Company	Trenz Electronic GmbH
PCN Number	PCN-20221116
Title	TEI0003-02 to TEI0003-03 Hardware Revision Change
Subject	Hardware Revision Change
Issue Date	2023-01-17

PCN-20221116 TEI0003-02 to
TEI0003-03 Hardware Revision
Change

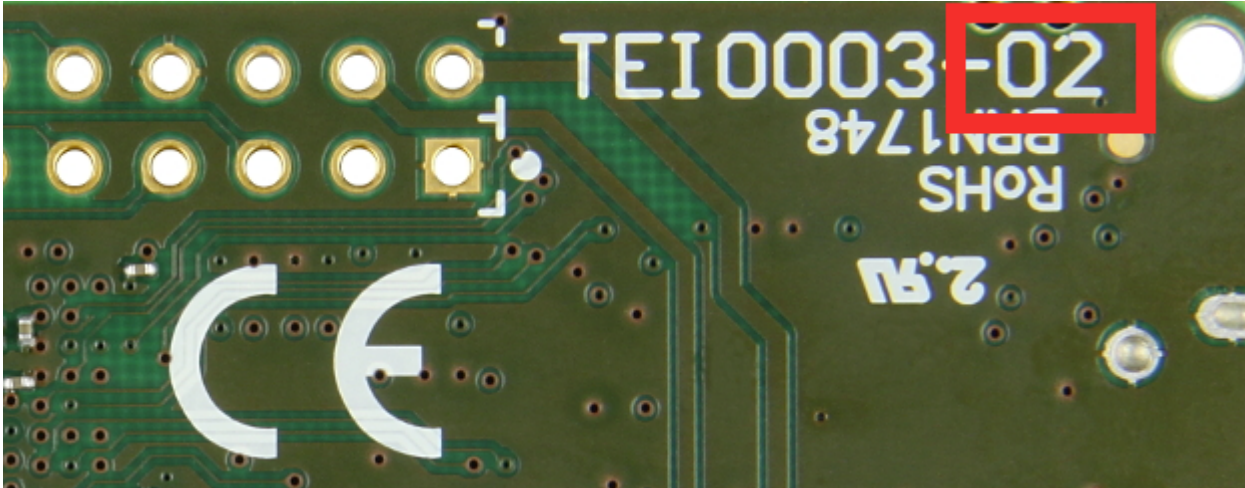
2.8 #8 Updated components from library.

Type: Schematic Change

Reason: Use latest component data.

Impact: None.
